Item Name: Strut Retrofit

# DART SERVICE INSTRUCTION

TO AMEND INSTALLATION INSTRUCTIONS D350-607-3 Rev.D,  
INSTALLATION INSTRUCTIONS D350-607-4 Rev. C AND  
INSTRUCTIONS FOR CONTINUED AIRWORTHINESS ICA-D350-607 REV. 6  
REF TCCA STC: SH94-14  
REF FAA STC: SR00213NY  
REF EASA STC: EASA.10016996  
REF BRAZILIAN STC: 2007S03-03/-04/-05/-06

A	NEW ISSUE	AJS	14.05.16
REV.	DESCRIPTION	BY	DATE
DESIGN	AJS	DART AEROSPACE LTD	
DRAWN	AJS	HAWKESBURY, ONTARIO, CANADA	
CHECKED		DRAWING NO.	REV. A
MFG. APPR.	N/A	DSI 9699	SHEET 1 OF 2
APPROVED		TITLE	SCALE
DE APPR.		LUG REPLACEMENT	NTS
DATE	14.05.16	COPYRIGHT © 2014 BY DART AEROSPACE LTD THIS DOCUMENT IS PRIVATE AND CONFIDENTIAL AND IS SUPPLIED ON THE EXPRESS CONDITION THAT IT IS NOT TO BE USED FOR ANY PURPOSE OR COMMUNICATED TO ANY OTHER PERSON WITHOUT WRITTEN PERMISSION FROM DART AEROSPACE LTD.

**FIGURE 1: INSTALLATION OF D4775-041 FWD STRUT**

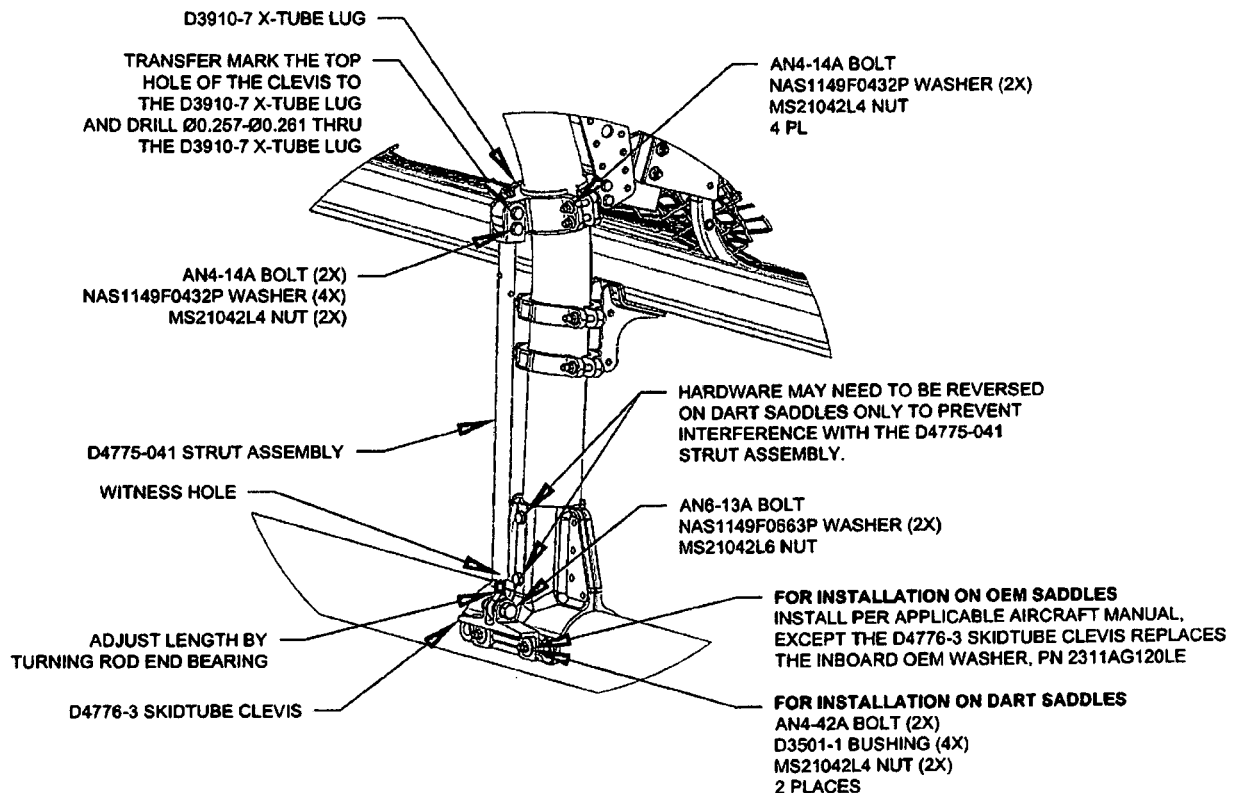
3.1 Substitute the Forward Lower D3910-5 X-Tube Lug with the D3910-7 X-Tube Lug as shown in Figure 1.

3.2 Install the forward D4775-041 Strut Assembly. Transfer mark from the upper hole on the clevis of the D4775-041 Strut Assembly to the D3910-7 X-tube Lug and drill thru the lug  $\varnothing 0.257$ - $\varnothing 0.261$  as shown in Figure 1. Touch up chemical conversion coating per MIL-DTL-5541. Check the witness holes located at the bottom end of the D4775-041 Strut Assemblies to ensure that the thread from the rod end extends past the witness hole.  
**Torque MS21042L4/-4 nuts to 50-70 in-lbs (5.7-7.9 N-m). Torque MS21042L6/-6 nuts to 160-190 in-lbs (18.1-21.5 N-m).**
